SERVICE BULLETIN

NUMBER: 12-203-16R
DATE: 07/14/16
REVISED: 01/12/21

SUBJECT: Squeaking Sound from Front Seat Buckle

**Shouldered
Portion**

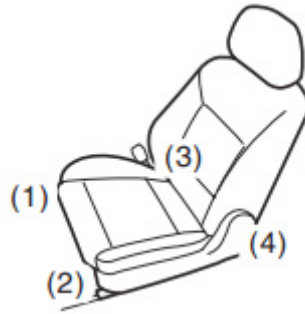
- Install the new spring wave washer onto the groove in the shouldered portion of the mounting bolt as shown below. The felt portion should be at about the 6:00 position (pointing down).
